**RE: Docket 4983 - 2020 Renewable Energy Growth Program Tariff and Rule Changes Responses to PUC Data Requests – Set 1**

The Narragansett Electric Company  
d/b/a National Grid  
RIPUC Docket No. 4983  
In Re: 2020 Renewable Energy Growth Program  
Responses to the Commission's First Set of Data Requests  
Issued on December 3, 2019

# Attachment PUC 1-10 Net Metering & REGrowth

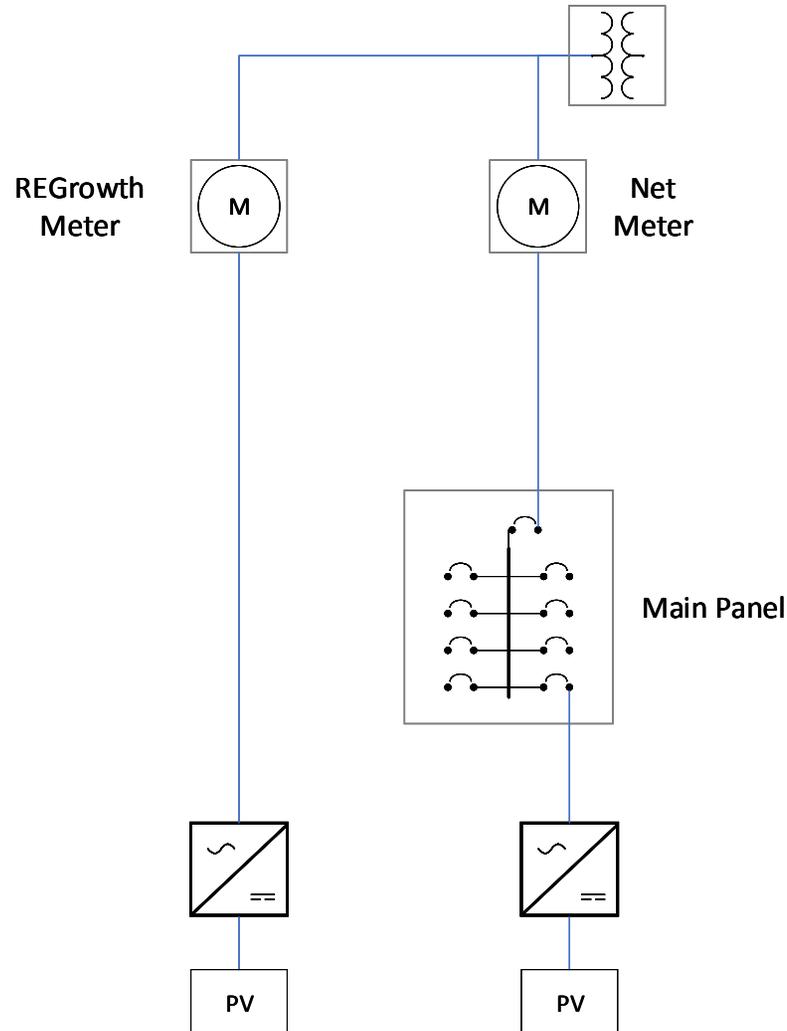
For any applicable pathways in PUC 1-9, please provide an engineering and non-engineering diagram of the proposed configuration(s).

Please see Attachment PUC 1-10 for a one-line illustration of a RE Growth solar facility connected at a customer premise along with a behind-the-meter solar facility, which could be enrolled under either the Net Meter Provision or the QF Provision. It would not matter which facility is connected first.

Note: Additional disconnections  
and protection equipment are not  
displayed

# Attachment PUC 1-16 DC-COUPLED

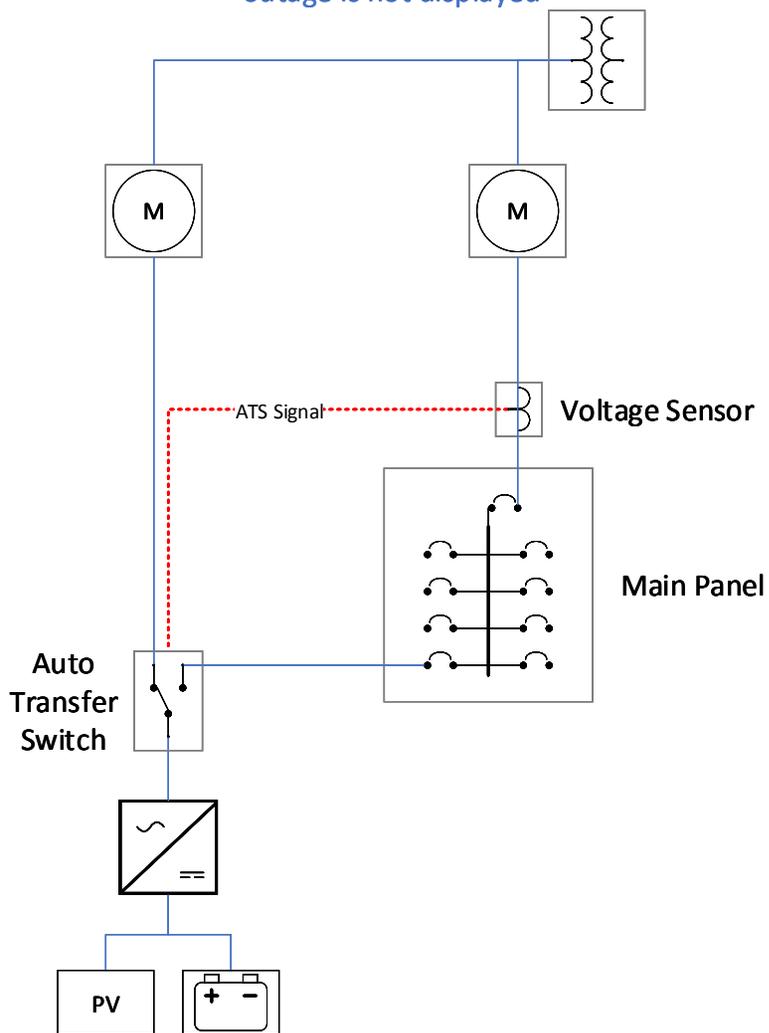
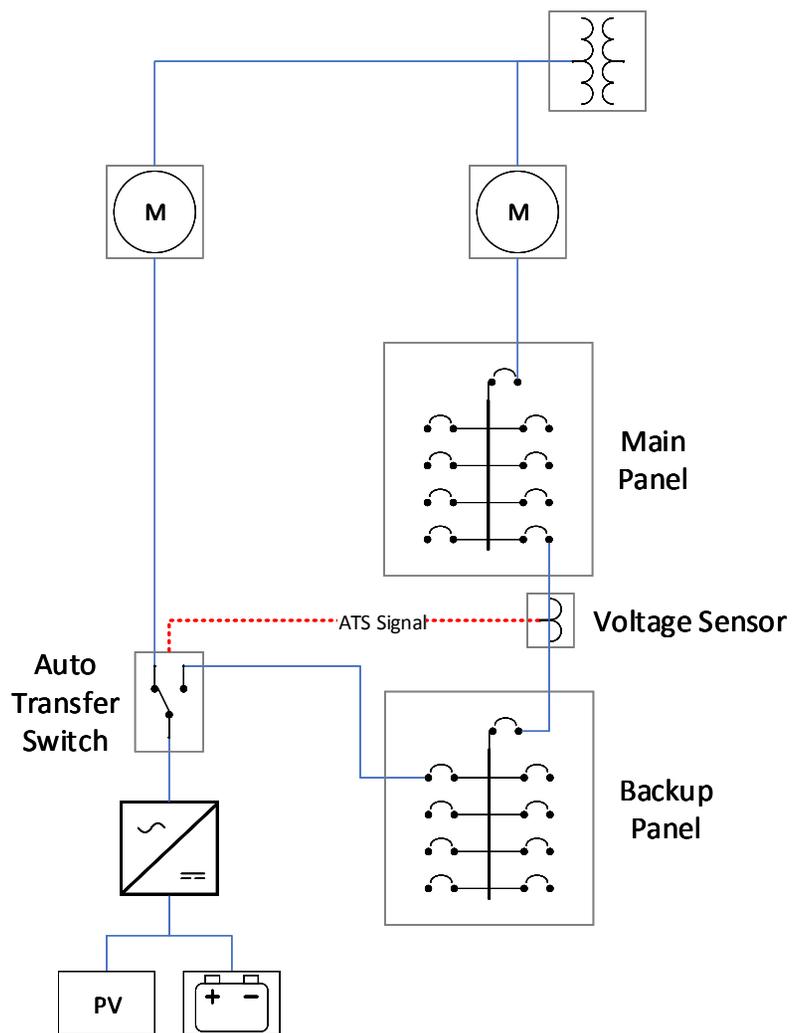
Referencing the energy storage explanation on page 14 of Mr. Springsteel's testimony, please provide an engineering and non-engineering diagram of the required configuration. At a minimum, include the generating facility, premise panel, and battery.

Please see Attachment PUC 1-16 for one-line illustrations of AC and DC coupled storage facilities with RE Growth solar facilities.

Note: Additional means to disconnect to open/reclose the connection between the meter and the main panel during an outage is not displayed

Note: Additional means to disconnect to open/reclose the connection between the main panel and the backup panel during an outage is not displayed
